SUBJECT: REVISED RELOAD TECHNICAL SPECIFICATIONS (TAC 00450) (TS 254)
BROWNS FERRY NUCLEAR PLANT, UNIT 2

Amendment No. 172
License No. DPR-52

SUPPORTING AMENDMENT NO.172 TO FACILITY OPERATING LICENSE NO. DPR-52

BROWNS FERRY NUCLEAR PLANT, UNIT 2

Figure 3.5.K-1 -
 MCPR Limits for P8 X 8R/8 X 8R/ QUAD+

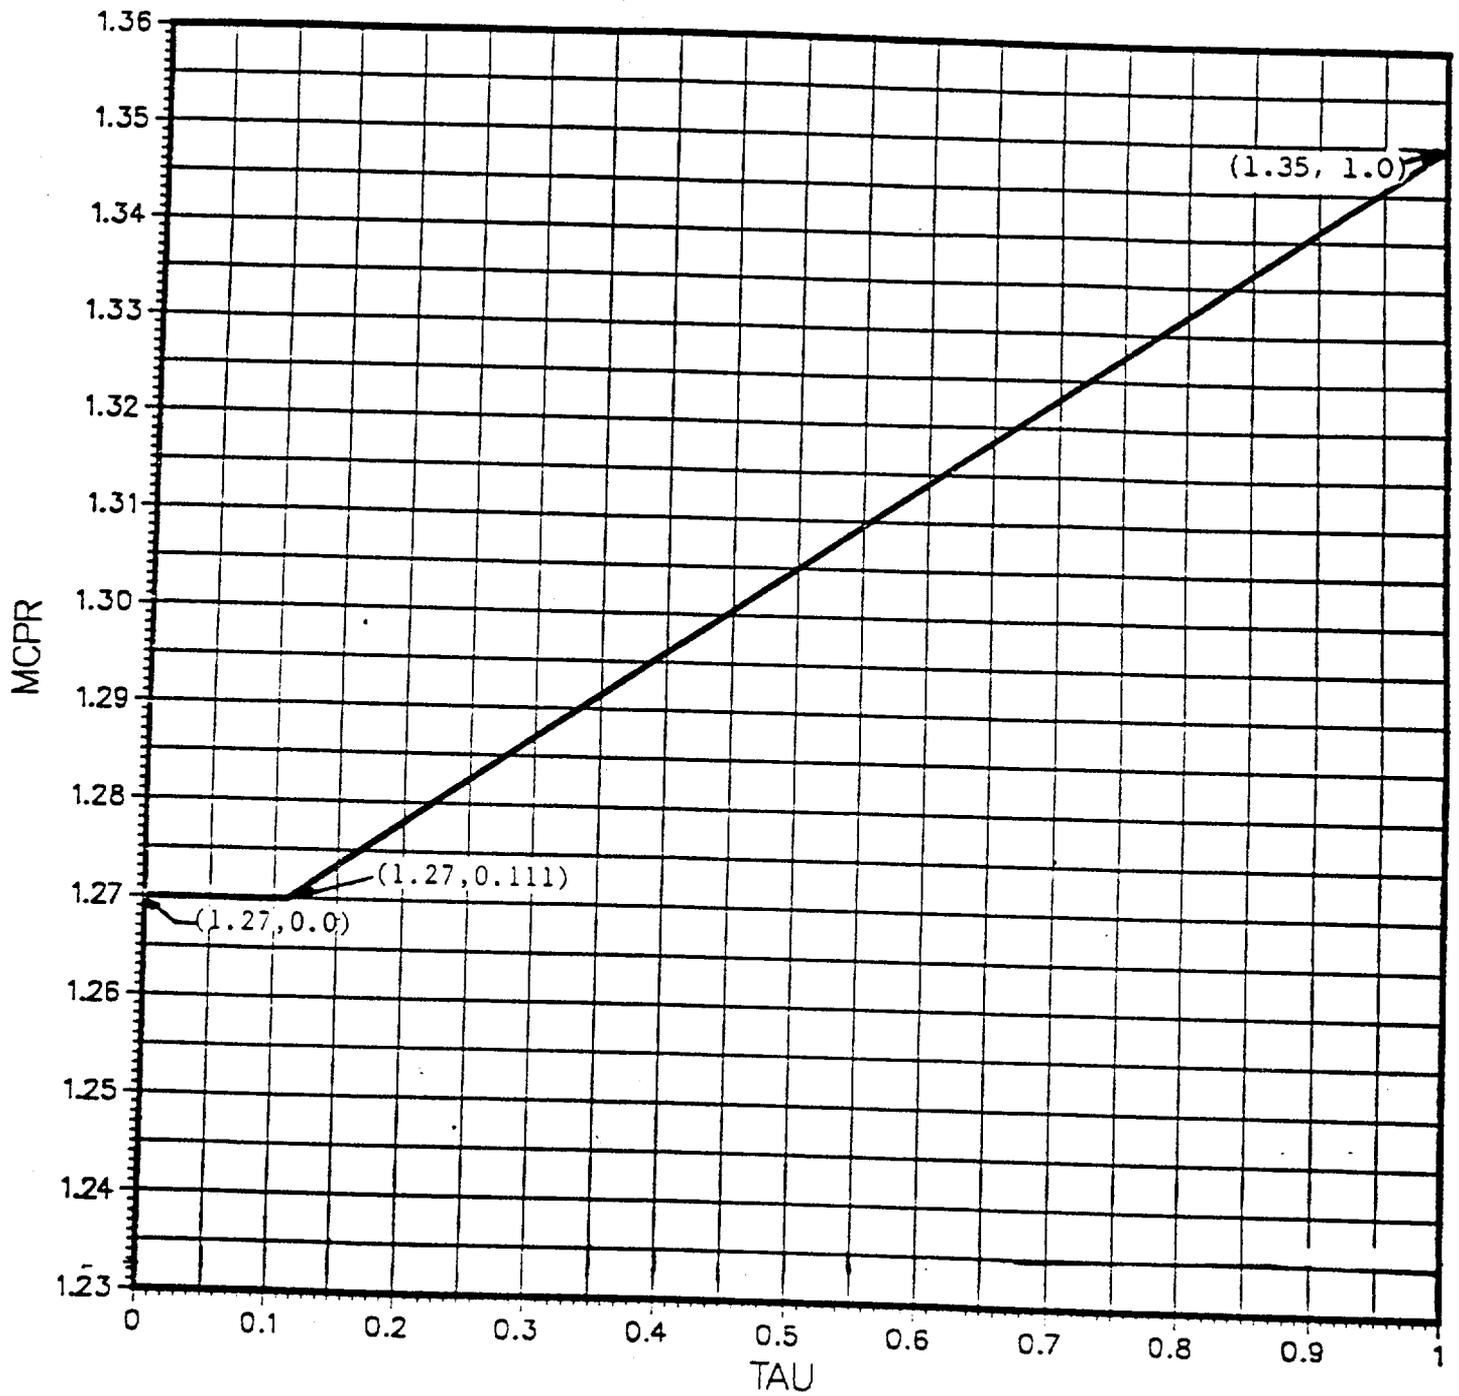
The Technical Specification (TS) changes proposed by the licensee reflect the new fuel to be loaded in the BFN Plant Unit 2 for Cycle 6 operation. These changes include core related changes for Linear Heat Generation Rate (LHGR) Limit, MCPR operating limits and MAPLHGR curves for the new fuel. Specifically, Tables 3.5.I.1 and 3.5.I.2 contained revised MAPLHGR limits based upon the licensee's acceptable reanalyses as discussed above. Tables 3.5.I-3 and 3.5.I-4 added new MAPLHGR limits for the two new fuel types resulting from the fuel reconstitution effort. Figure 3.5.K-1 provides a revised curve for calculating MCPR limits again based upon the licensee's revised analysis.

The minimum critical power ratio (MCPR) as a function of scram time and core flow, shall be equal to or greater than shown in Figure 3.5.K-1 multiplied by the K_F shown in Figure 3.5.2, where:

2. The MCPR limit shall be determined for each fuel type 8X8, 8X8R, P8X8R, from Figure 3.5.K-1, respectively, using:
